RE: Coors Corridor Plan

Response to COA Planning's Aug. 14, 2014 Draft VP Regs. - Pat Gallagher, La Luz Landowners Assoc.

Coors Corridor Plan Draft Regulation Revisions

Comments re Coors Corridor Plan by a Resident of Andalusia

Figure D-10: Structure Mass in VP sub-area

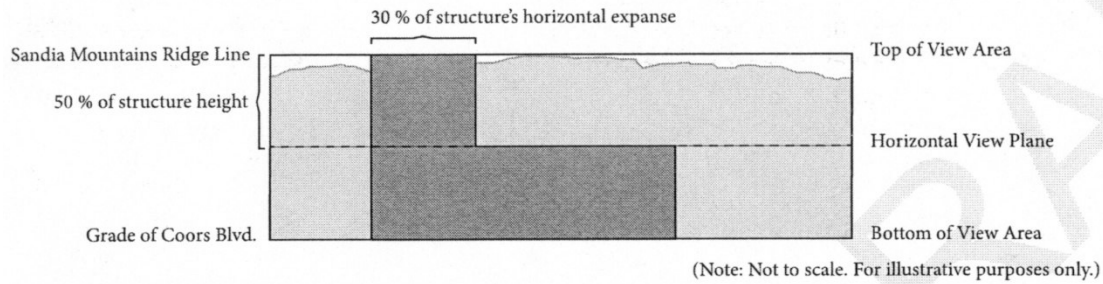
Figure D-10 on page 108 (below) shows how this regulation intends to be applied:

Then along comes the property owner to the NE. He builds an allowable building that looks like this:

With the new language that sets a minimum height (could be called the short building loophole), a different owner of the property next to Coors decides to try it out. He builds up the elevation of the property to Coors grade and puts a string of 19.5' tall commercial buildings at the edge of the setback. Here is what the allowable view frame would look like:

This appears to be the end of view preservation.

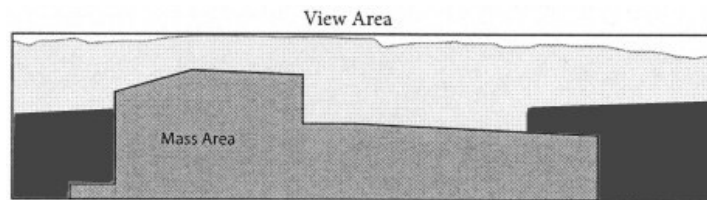
It is simpler to analyze a property for view compliance if it is all by itself. When looking at *massing* it becomes particularly important whether other buildings in the view frame are part of the developed mass. The intent of the regulation is to insure a reasonable proportion between the total view and the total mass of buildings in the view. On page 105 the figure correctly shows the proportions:

If a developer wanted to put a building in front of some older buildings, the massing analysis does not have to consider the original buildings. Below is the same picture with the background buildings shown.

The top picture would pass and the lower picture would not. In the spirit of the regulation, it is clear that the isolation approach does not protect and preserve views. Massing analysis should be done in the true context of the site. This point needs to be clarified in the regulation.

Figure D-3: View Frames and Sight Lines and View Area for a Site off Coors Blvd. – Plan View

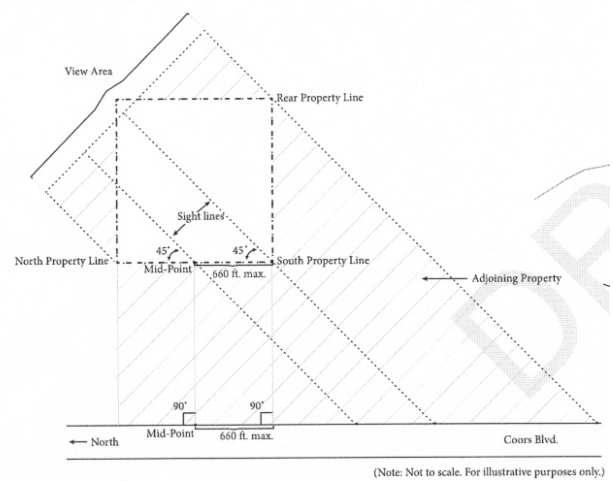
The draft regulation conspicuously avoids placing a sight line onto the subject property that does not pass through the property frontage. This error has been addressed at each meeting but never corrected. It leaves a giant loophole. There has never been a question that sight lines will emanate from 4' above the edge of Coors at 45° to anywhere on the property that is relevant. Perhaps this is another way of attempting to evaluate each property in isolation. The purpose and function of a sight line has nothing to do with frontage property lines.

Sight lines are selected to study relevant features of a building. Typically the highest points are selected. The draft revision always shows the first sight line passing through the frontage intersection with the south property line. Someone trying to decipher the regulation would assume that the first sight line always passed through the frontage south corner. This leaves the upper right half of the property out of being scrutinized. It should be made clear that sight lines can be anywhere on the site and as many or few should be used to address the building's features. Usually one or two sight lines are needed to characterize a building. Long sites like residential neighborhoods require a series of sight lines.

Figure D-4: ~~View Frames and View Area with Structures~~ (Site Development for Building Permit) – Plan View

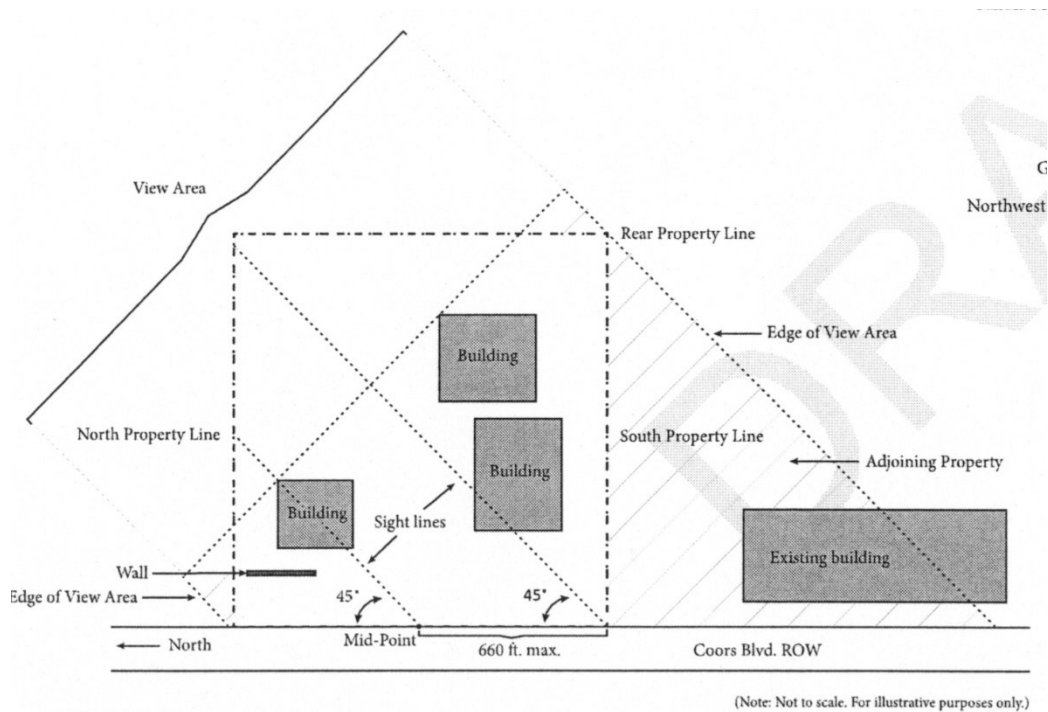
Sight lines are simple and easy to define and understand. The draft needs to correct and simplify these illustrations, remove the midpoint and 660 ft reference and show that sight lines can apply to any part of the property. Also it is confusing to call the above Figure D-4 “View Area” because the view area as previously defined does not appear in the Plan View.

Figure D-10: Structure Mass in VP sub-area

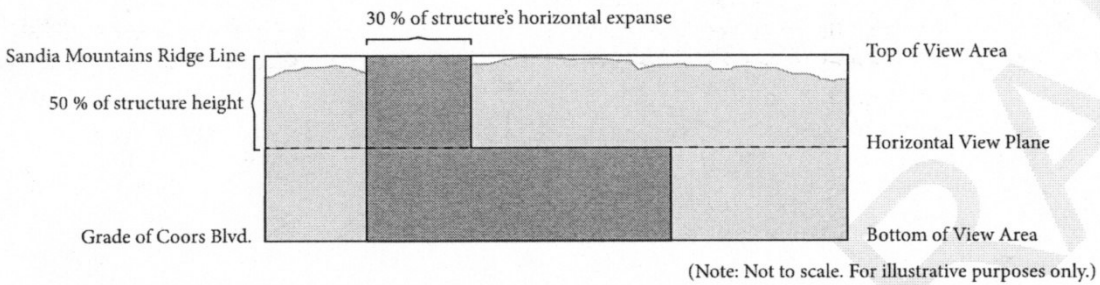
It is clear in the figure below that the draft intends to allow penetration of the ridge line.

Taken to the extreme, this will allow complete obscuration of the mountain.

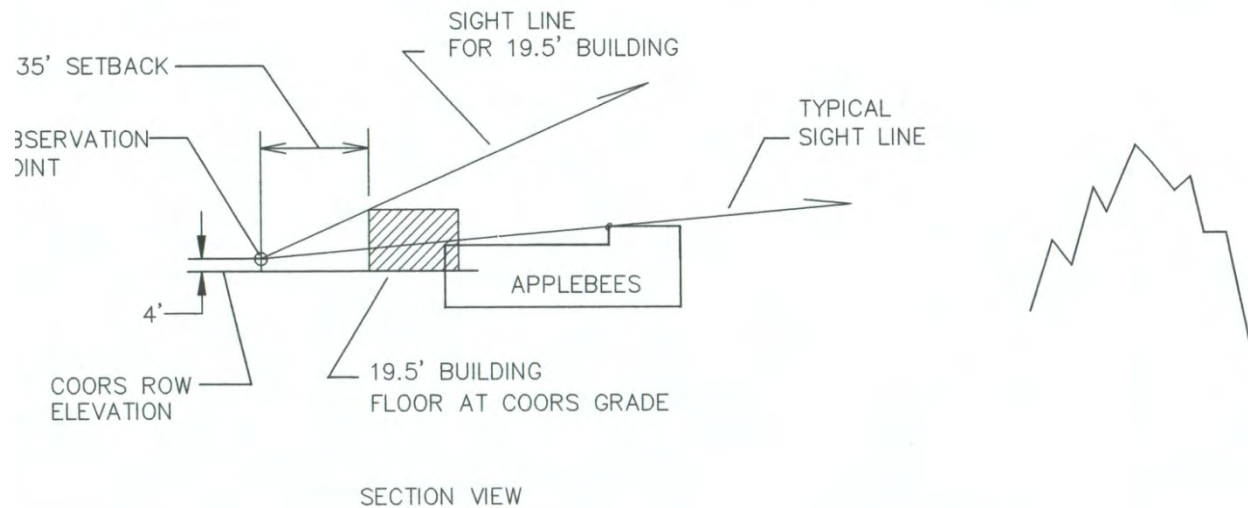
Perhaps the most disastrous of all the new revisions to the Coors Corridor Plan is the exemption of buildings that are less than 20' tall for commercial applications and 16' for residential.

To fix this, the city is proposing a cut-off, a minimum building height, below which an exemption is granted. The draft plan does not say it this way, but that is the outcome. Commercial buildings below 20' can be built anywhere and are exempt from the view preservation requirements. Similarly, residential buildings below 16' are exempt.

The figure below is a section view in the plane of the sight lines. It shows a short (19.5') building in correctly scaled context at the minimum setback. This building would completely obscure a view of the mountains, (distance to the mountain is not to scale).

The figure above shows the impact of allowing a height exemption for buildings under a given height. This particular exemption would obscure all views of the mountain where buildings are built close to Coors.
